Access Compliance Report

Public Rights-of-Way

(Curb Ramps)

Intersection ID: 8749	Main Street: BARRINGTON_DR	Cross Street: OLD_COACH_RD	Location: S
ADA ID: A8167E9B7A48	Ramp Type: Perp	Initial Pass/Fail: Fail	Overall Compliance: No
Severity Score: 13.75			
Codes/Mitigation Info/Possible Solution		Field Measurements/Component Compliance

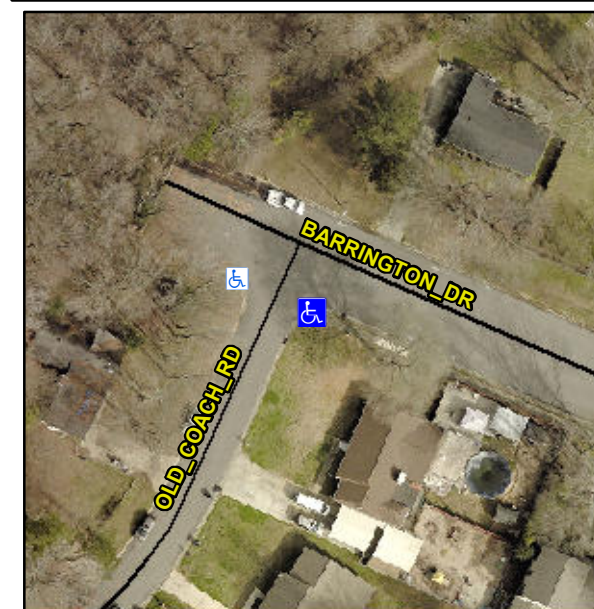
Not Found, R304.2.2, R304.5.3

Compliance	Description	Data	Compliance	Description	Data
N/A	Ramp Length (in)	28.0	No	Ramp Slope (%)	10.7
Yes	Ramp Width (in)	48.0	No	Ramp XSlope (%)	2.9
N/A	Flare Type LT	N/A	N/A	Flare Type RT	N/A
N/A	Flare Slope LT (%)	N/A	N/A	Flare Slope RT (%)	N/A
N/A	Flare Traversable LT?	N/A	N/A	Flare Traversable RT?	N/A
N/A	Landing Length (in)	N/A	N/A	DWS Provided?	N/A
N/A	Landing Width (in)	N/A	N/A	DWS Contrast?	N/A
N/A	Landing Slope (%)	N/A	N/A	DWS Length (in)	N/A
N/A	Landing X Slope (%)	N/A	N/A	DWS Full Width?	N/A
N/A	Landing Curb? (Y/N)	N/A	N/A	DWS Offset (in)	N/A
N/A	Shared Landing?	N/A			
N/A	Gutter Ponding?	N/A	N/A	Gutter Slope (%)	N/A
N/A	Gutter Lip Ht (in)	1.0	N/A	Gutter X Slope (%)	N/A
N/A	Painted X Walk1?	No	N/A	Painted X Walk2?	N/A
	X Walk 1 Direction	To NW		X Walk 2 Direction	N/A
N/A	X Walk 1 Width (in)	N/A	N/A	X Walk 2 Width (in)	N/A
	X Walk 1 Slope (%)	2.6		X Walk 2 Slope (%)	N/A
	X Walk 1 X Slope (%)	0.4		X Walk 2 X Slope (%)	N/A

Remove & Replace Entire Ramp.
